Bitters Pump Station Upgrades and Tank Replacement (RFCSP)

Solicitation Number: CO-00601

ADDENDUM No. 2

June 28, 2023

D-505

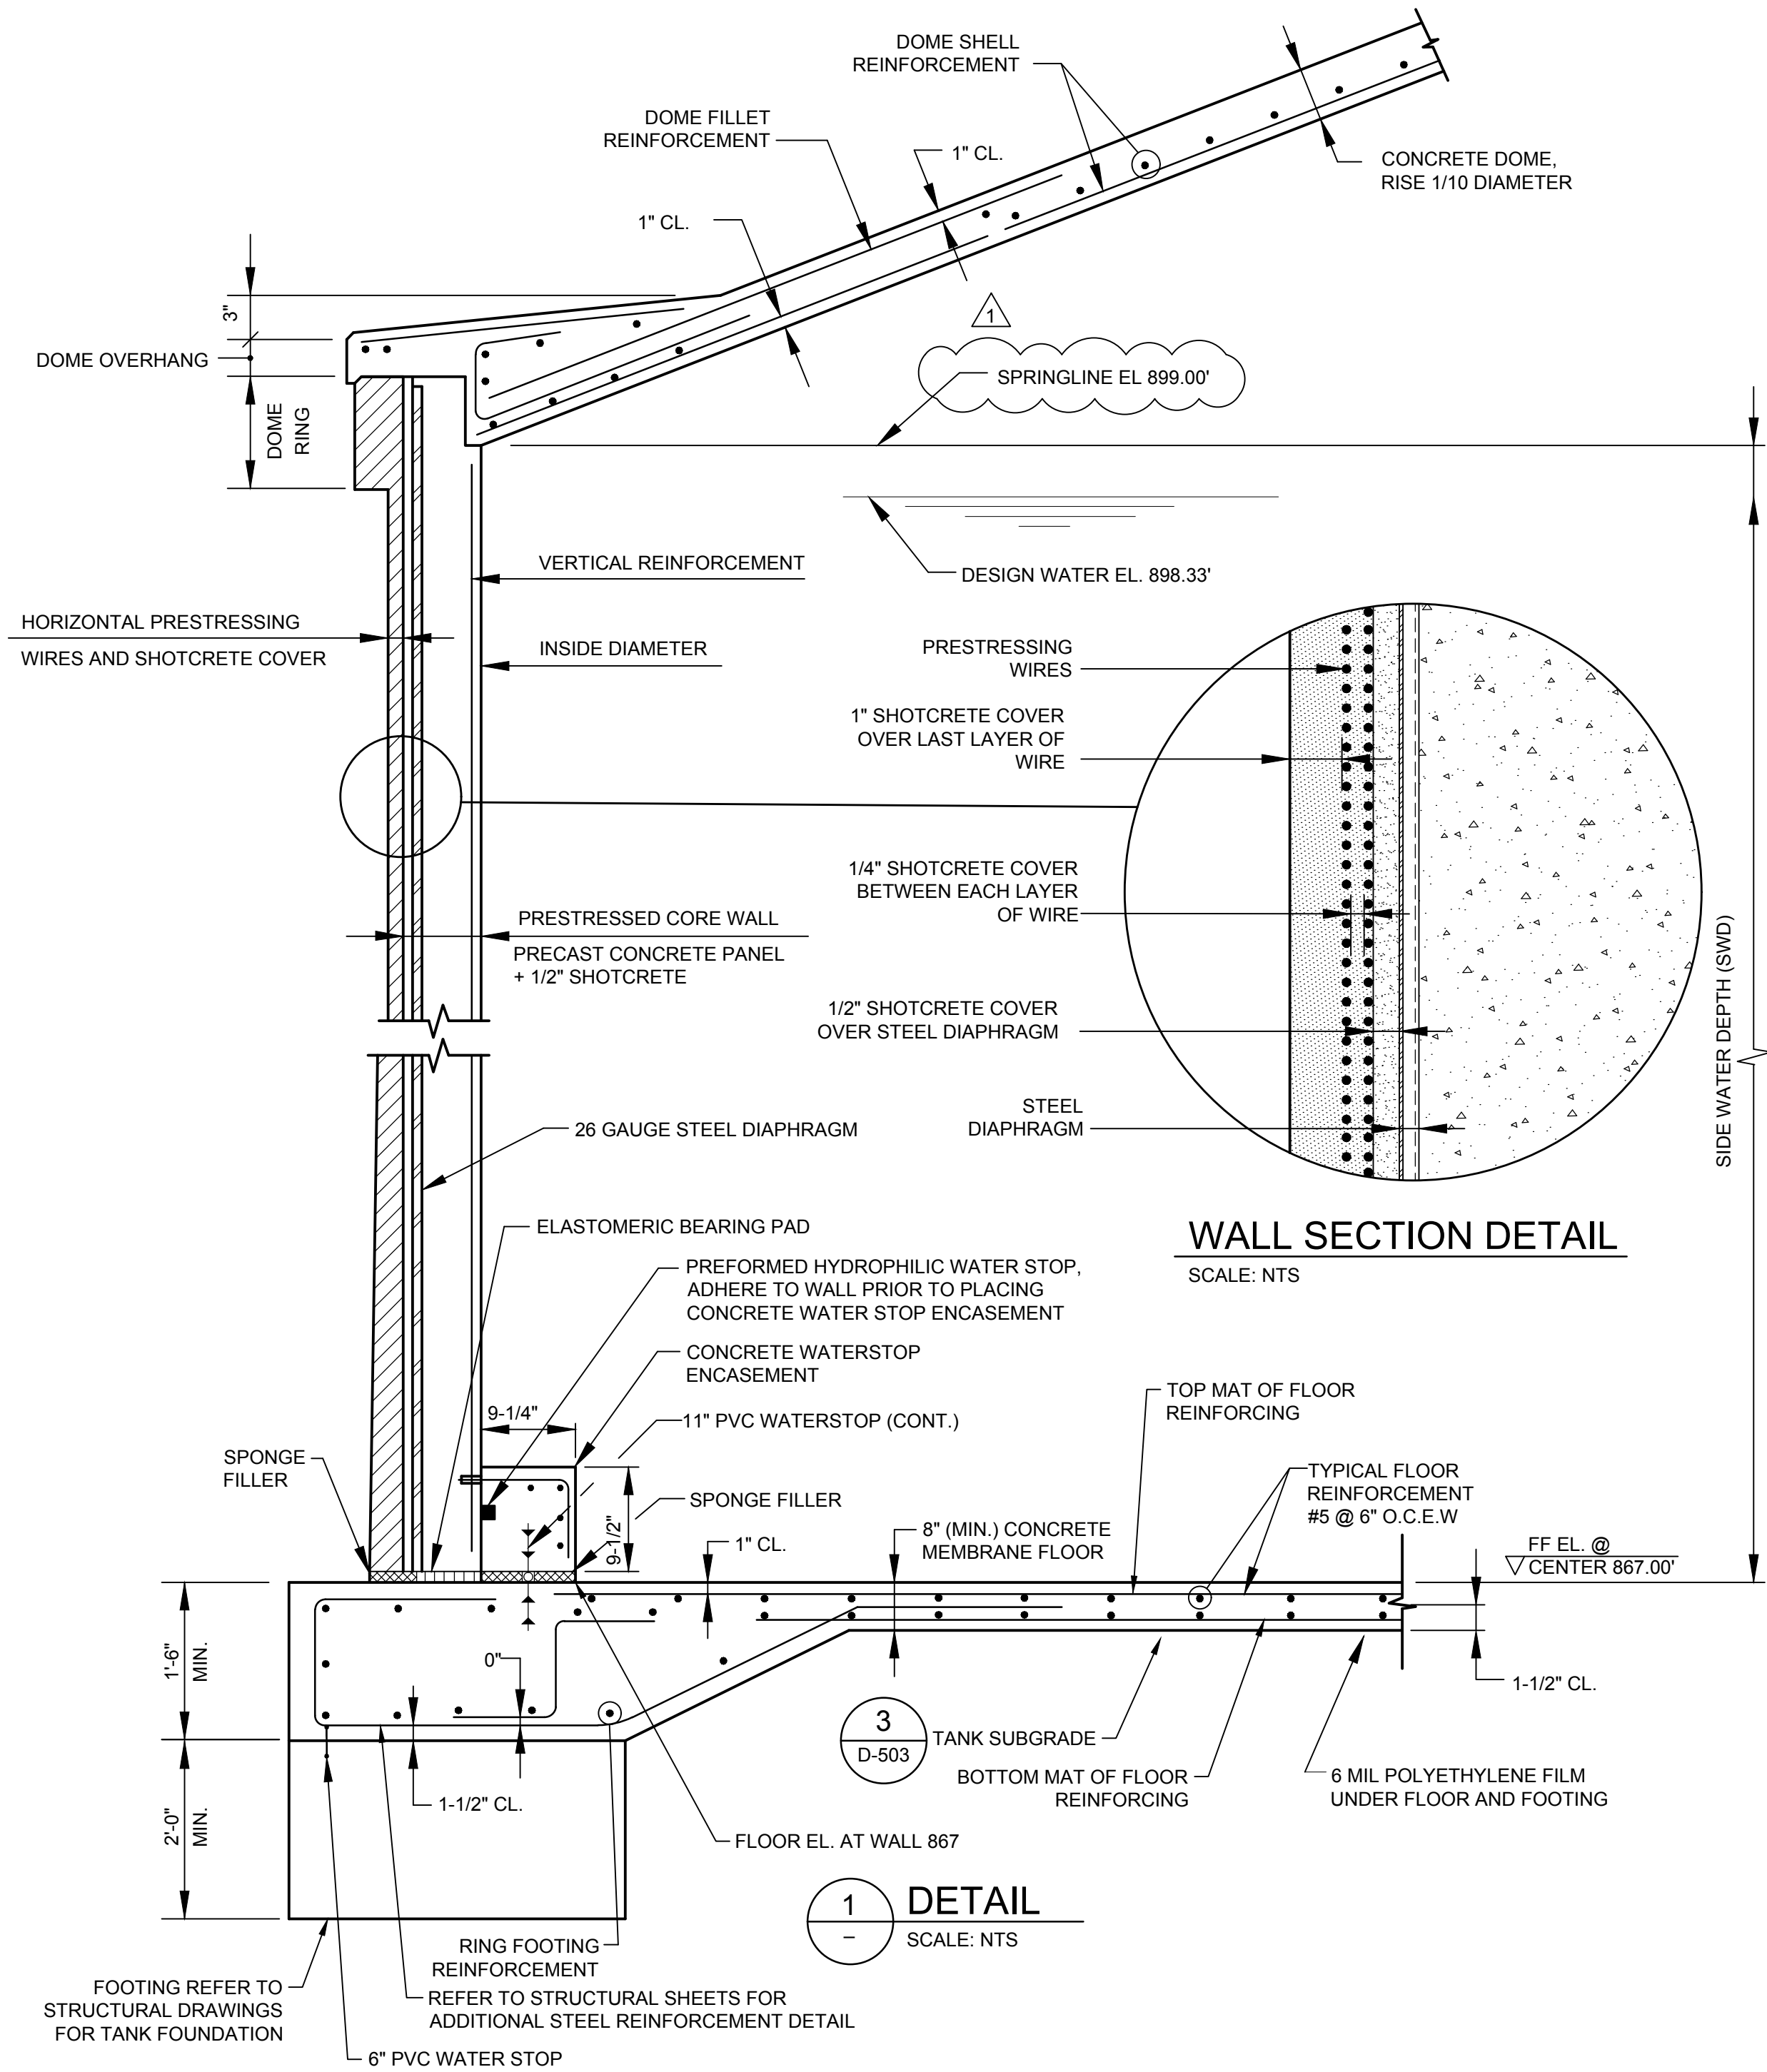
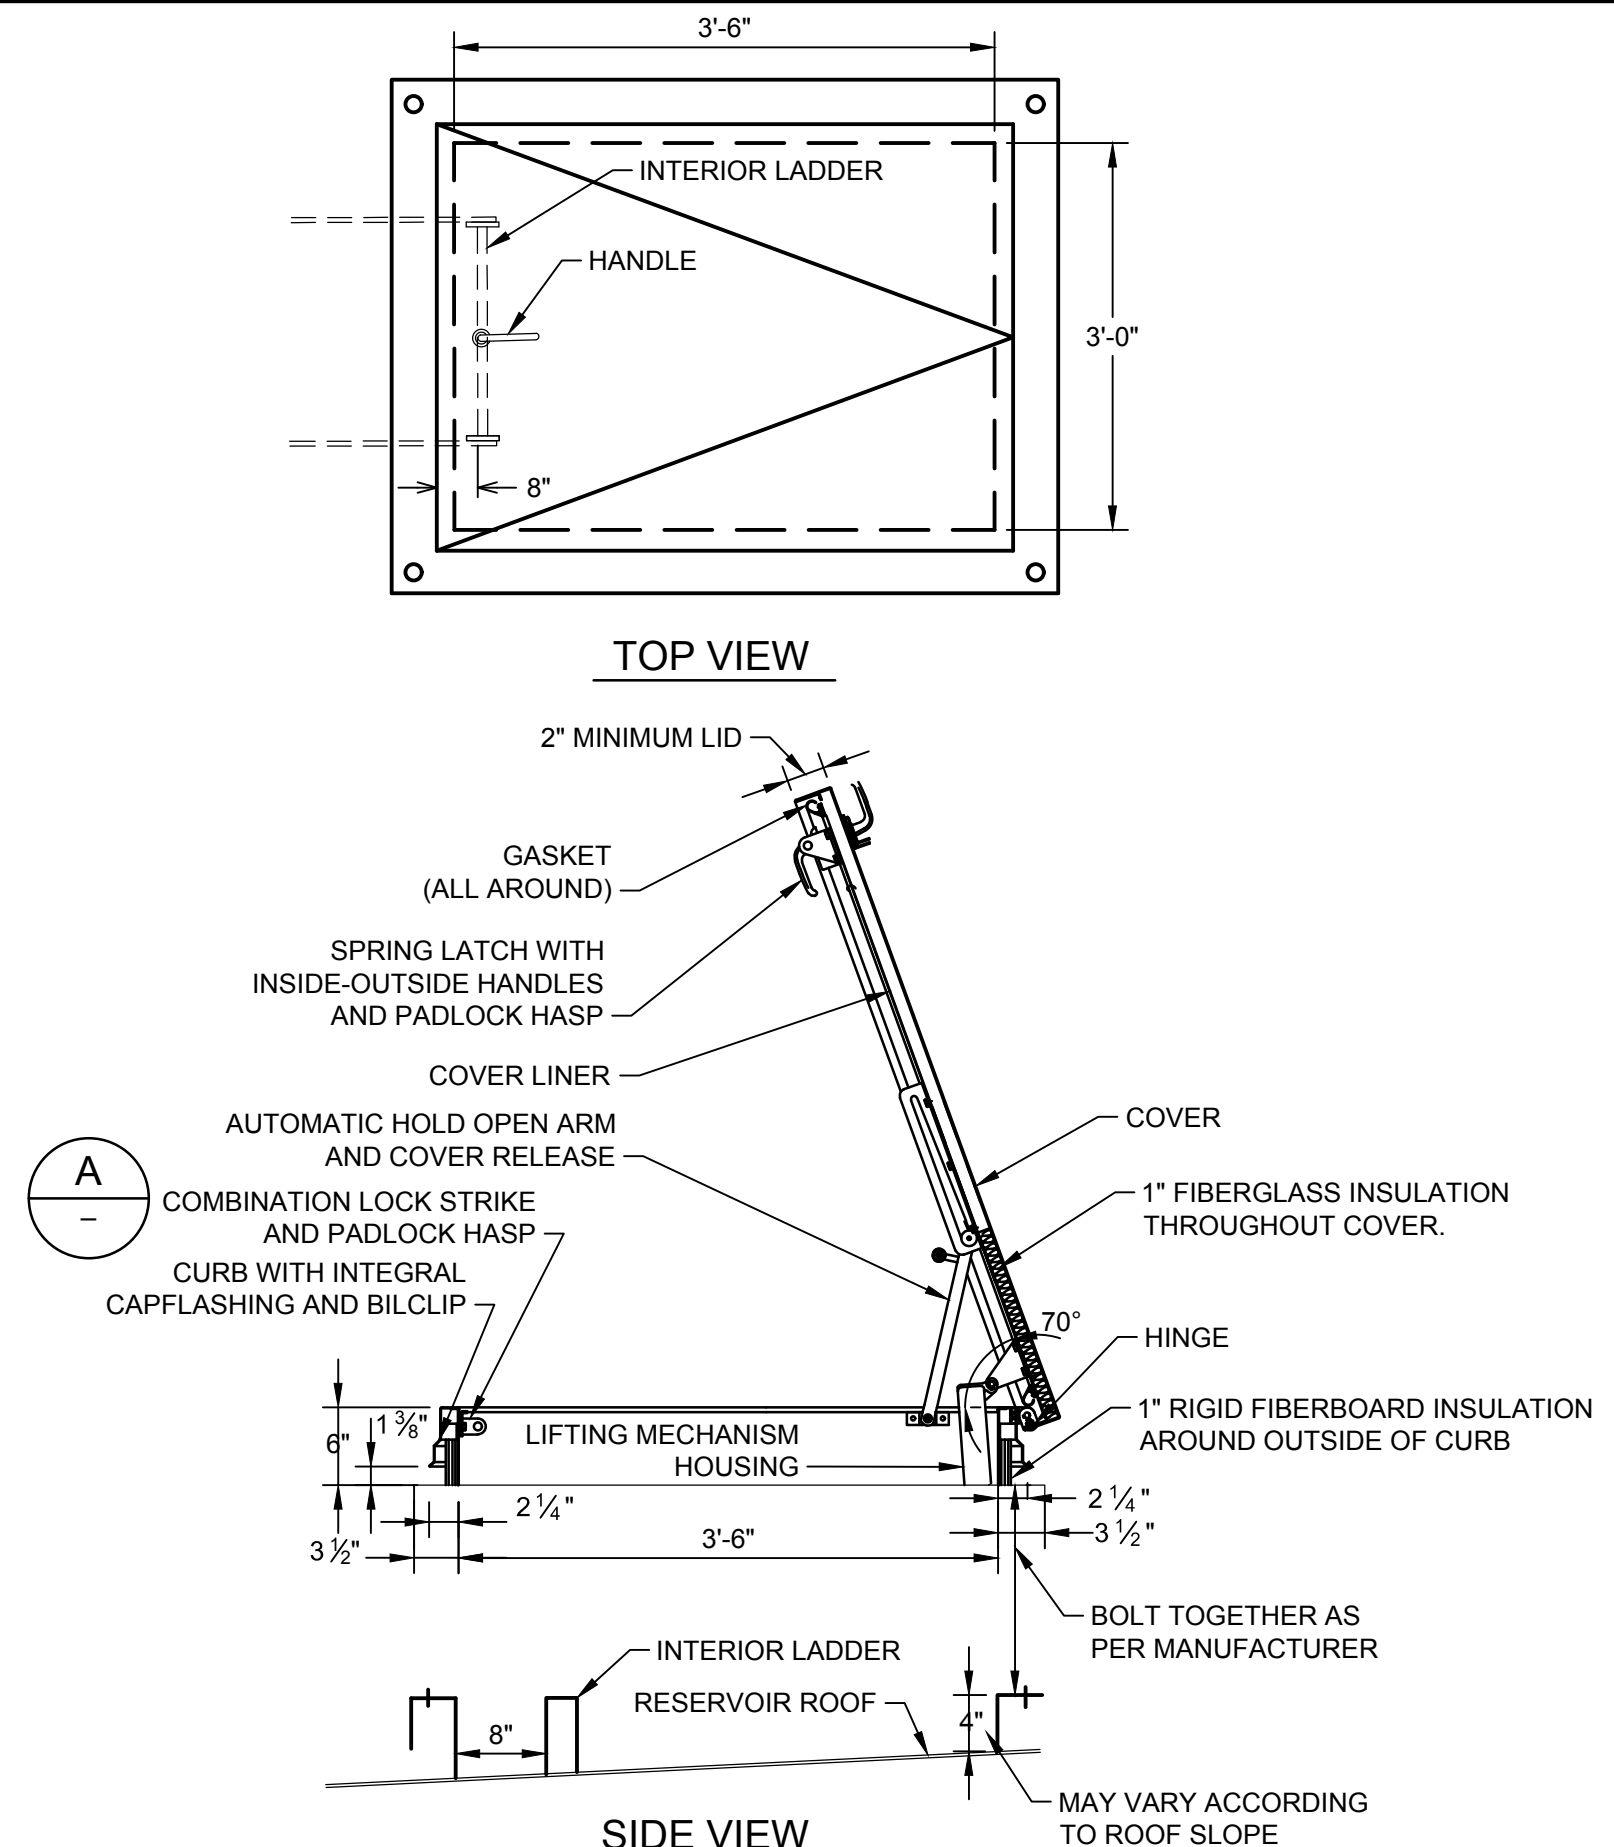
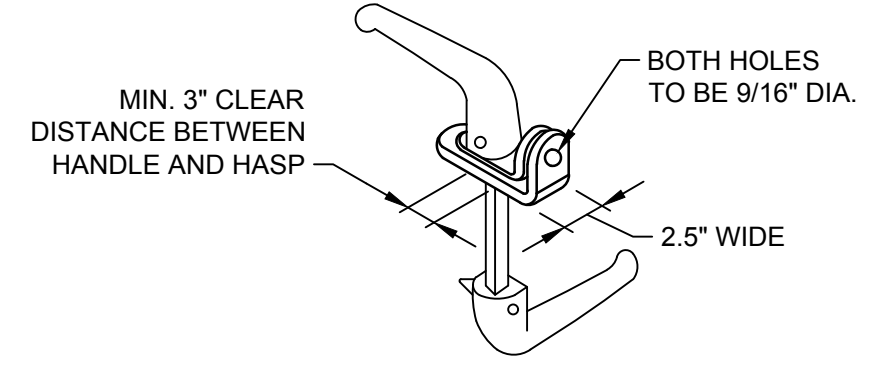
6. **Question: Specification Section 13207, Article 2.02.A, specifies tank floor minimum thickness of 6” while Contract DWG. D-505 shows an 8” thick floor. Please confirm the required floor minimum thickness shall be 8”.**

11. **Question: Specification Section 13207, Article 2.06.C, indicates the two roof hatches must be a 42”x36” but specifies two different hatches for two different sizes. Please confirm what hatch will be required for this tank hatch. Please note Bilco does not manufacture a 42”x36” Aluminum Type D Hatch. Please specify the exact model required.**

- 17. Question: Contract Drawings, Sheet D-505, Detail 1, calls Springline El. At 899.33 while D-101 calls for Springline at 899.00. Please confirm the Springline shall be 899.00 to match the previous Bitters Road project.**

Response: See "Changes to the Specifications" item 3, Section 13207 – Wire-Wound Prestressed Concrete Tank with Steel Diaphragm. Minimum floor thickness shall be 8” as noted on contract drawings D-505 and S-102.

Response: See “Changes to the Specifications” item 3, Section 13207 – Wire-Wound Prestressed Concrete Tank with Steel Diaphragm. Hatch size shall be 42” x 36” as noted. Hatch shall be Halliday F1R series.

Response: See "Changes to the Plans" Sheet D-505, item 2. Springline shall be 899.00 as shown on D-101.

1. DRAWING G-002 – GENERAL NOTES
 - REMOVE and REPLACE in its entirety with attached.
2. DRAWING D-505 – STANDARD PROCESS DETAILS V
 - REMOVE and REPLACE in its entirety with attached.
